PRODUCT SUPPORT BULLETIN BULLETIN NO. 361

MACHINE: **Super Claws and Grabber Spike Pullers**

SUBJECT: **Pulling Head Roller Frame Narrow Lower Cross Member**

Figure 1
Original Design Cross

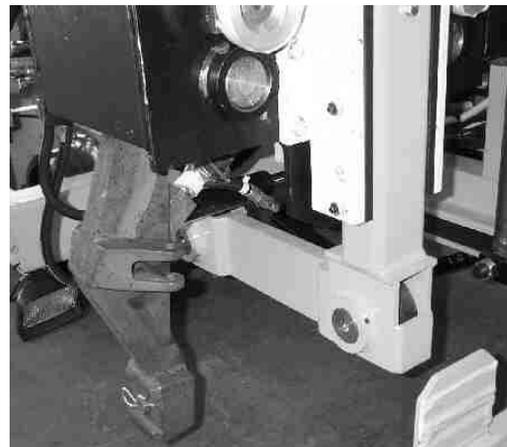
When the spike pulling claws on these machines are completely closed, the claws can drag on the lower cross member of the Roller Frame. In time, this will wear grooves in the cross member and the Roller Frame would have to be repaired or replaced.

To prevent this from wear, the **Roller Frame, p/n 34700022**, has been redesigned with a narrow cross member. With this change, the claws cannot rub on the cross member so there will be no wearing of the cross member. The original Roller Frame Cross Member is a U-shaped bent plate as shown Figure 1. The new Cross Member is a solid steel bar as shown in Figure 2.

Grabber Spike Pullers (2 Pulling Heads) serial number 330617 and higher and Super Claw Spike Pullers (1 pulling head) serial number 350512 and higher were built with the narrow cross member roller frame. The new design will be furnished on any repair orders
